## MEMORANDUM

**DATE:** November 9, 2012

**SUBJECT:** ZC 12-18 - Setdown Report: Consolidated PUD and related Map Amendment from the R-4 to R-5-B and HS/C-2-B districts for specified lots in Square 858.

**Proposed Alley Closure – Shown as cross-hatched**

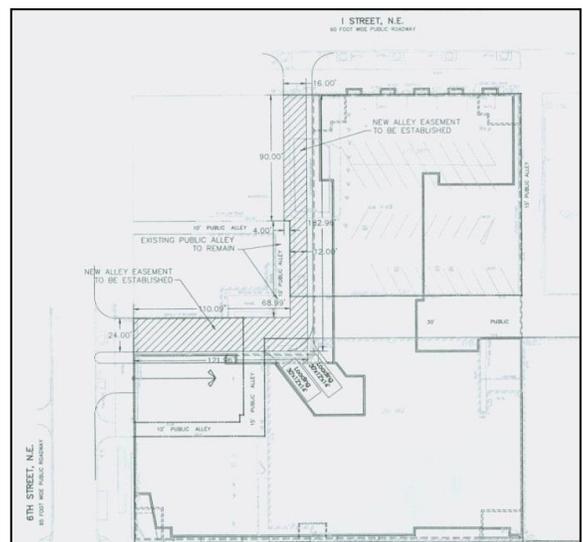
Phase I development includes portions of the existing alley which are proposed to be closed and the remaining alley system reconfigured. As shown in the applicant's diagram below, the existing east-west alley between 6<sup>th</sup> and 7<sup>th</sup> Streets would be removed to accommodate the north wing of Phase I. The north-south and east-west portions of the alley abutting the Murray's parking lot would be removed to accommodate the west wing of Phase I. A new 24-foot wide dedicated public alley easement would connect 6<sup>th</sup> Street to I Street. It would be widest at 6<sup>th</sup> Street at 24 feet and emerge at I Street 16 foot in width. However, the alley width of the new north south portion, abutting the residential Lots 21-23 would be at least 22 feet wide. Thus, the reconfigured alley would increase the existing widths to serve existing residents and to provide the required turning radii for vehicles entering the alley to access Phase I's loading and parking areas.

The alley reconfiguration requires a separate approval by DC Council. Any condition of approval of development by the ZC would be conditioned on the applicant receiving this approval.
